Preliminary/ Final Drainage Report

**McGehee Tract
El Paso County, Colorado**

December, 2020

Please add the
following "PCD No.
SF2011"

MCGEHEE SUBDIVISION
DRAINAGE PLAN
EXISTING CONDITIONS

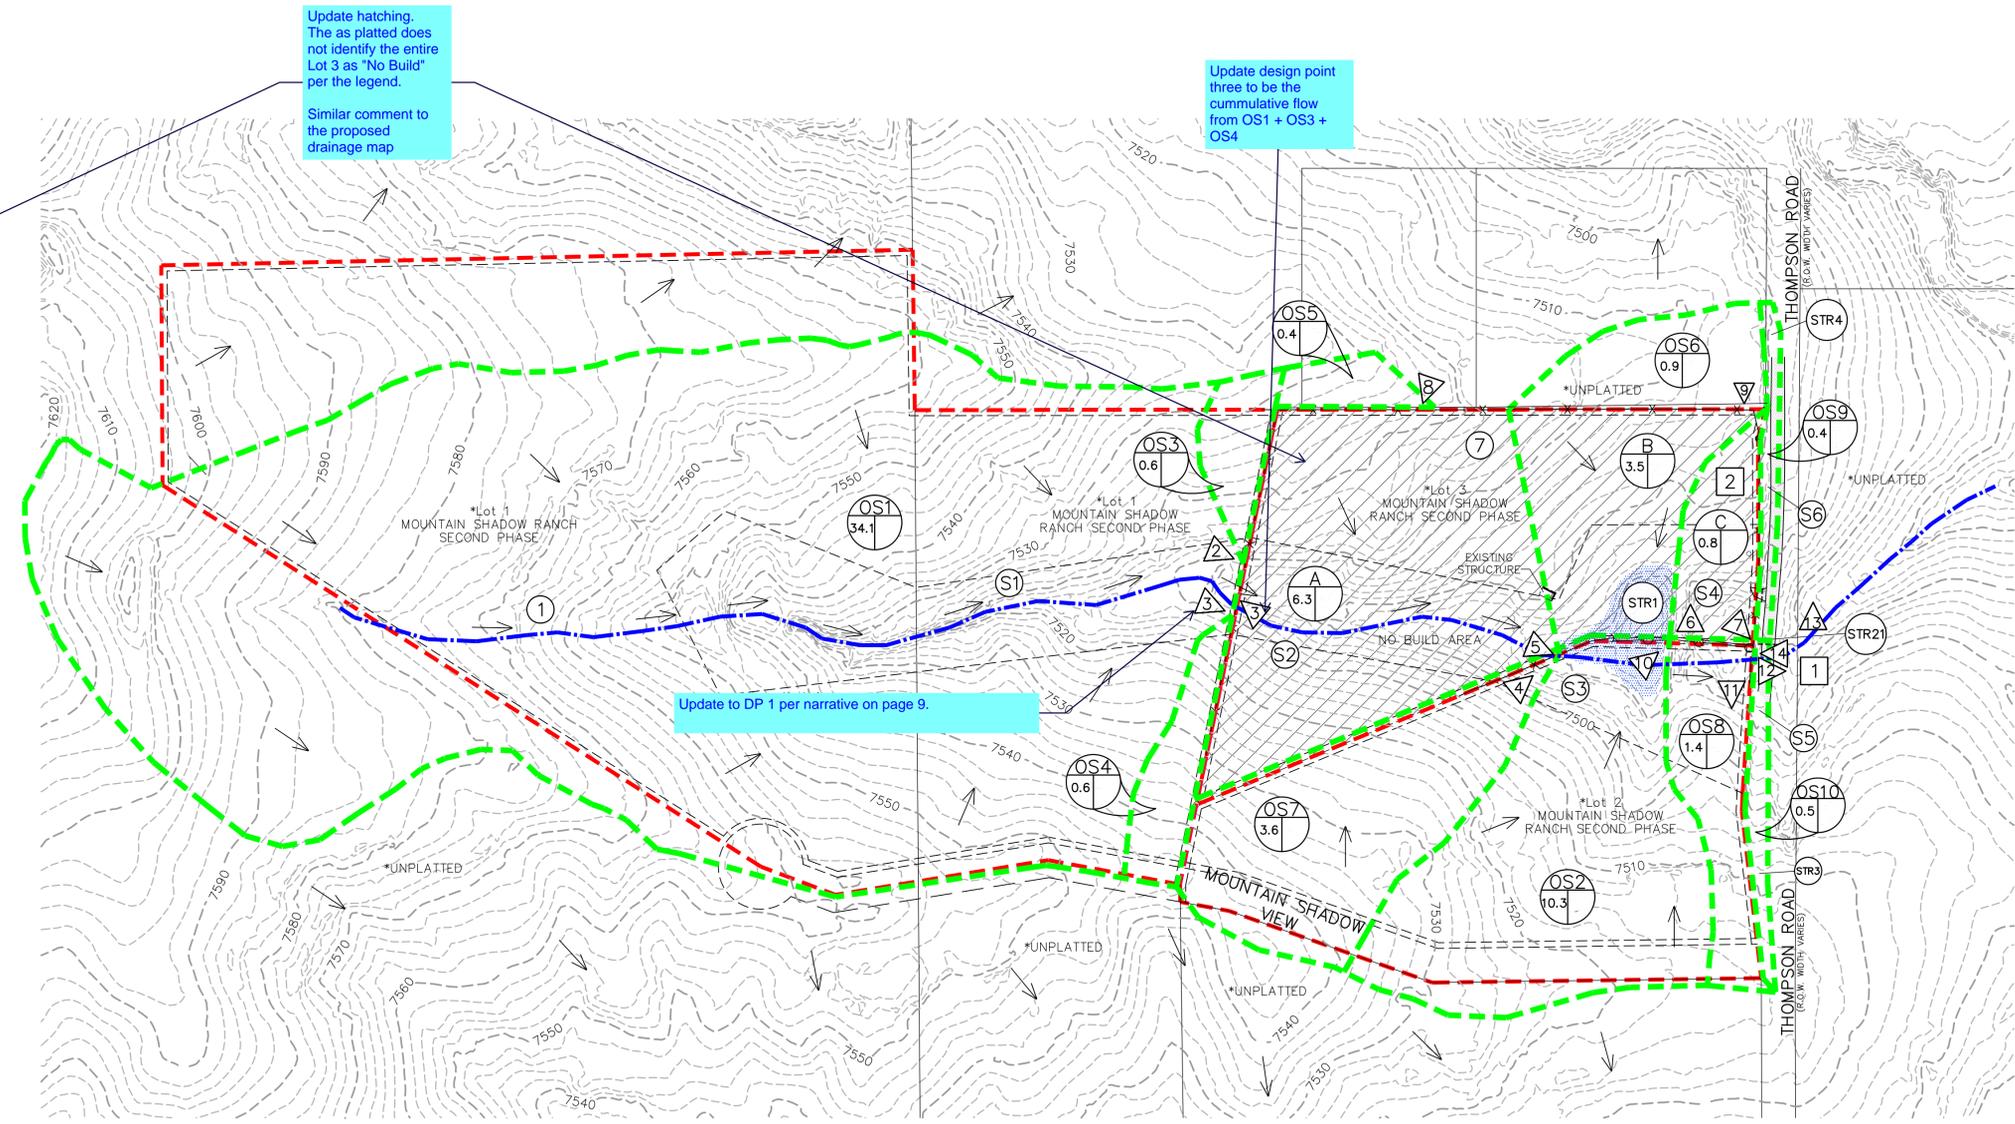
Add a row for S7
Revise to be in S1, S2... format for clarity (so it matches map below)

Project No.: 20018
Sheet: 1 of 1
MCGEEHEE SUBDIVISION DRAINAGE PLAN DEVELOPED CONDITIONS

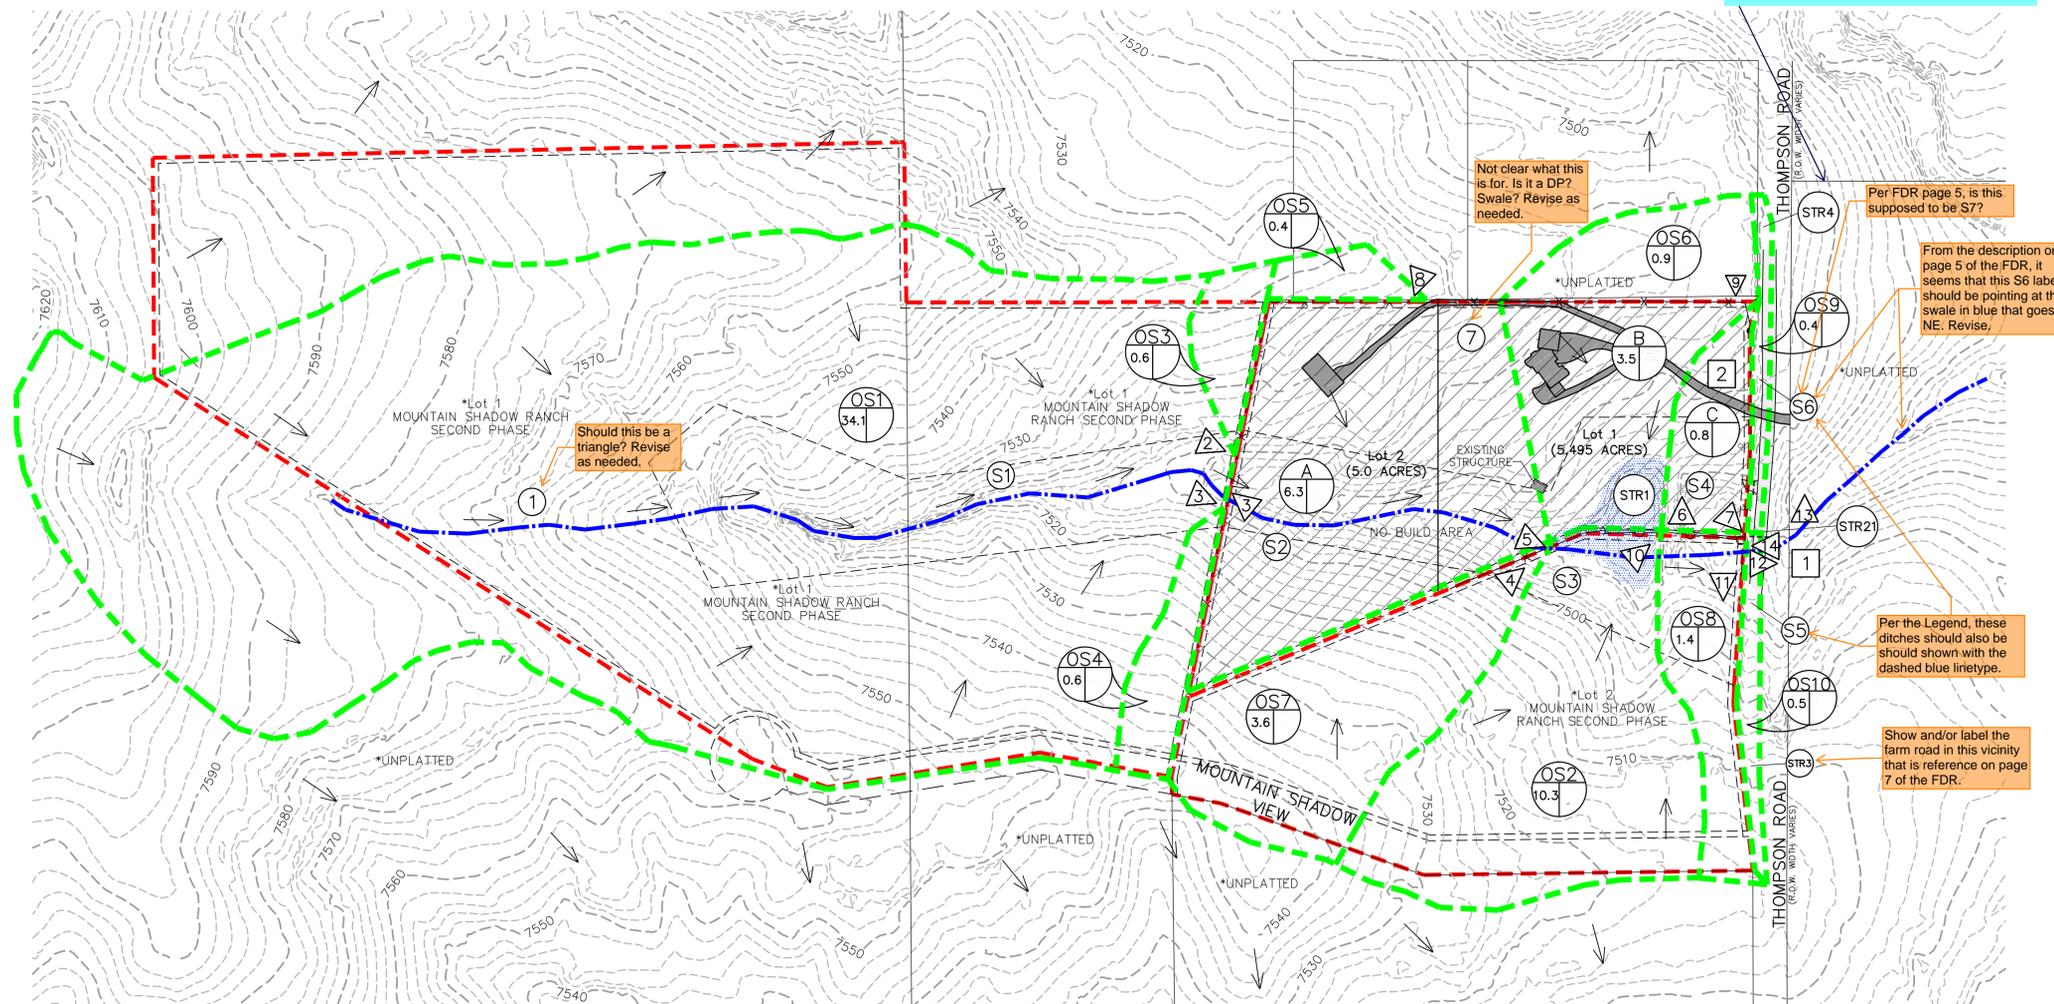
STR4 is shown offsite. Update location. The narrative on page 7 noted this is 150 south of the NE property corner.
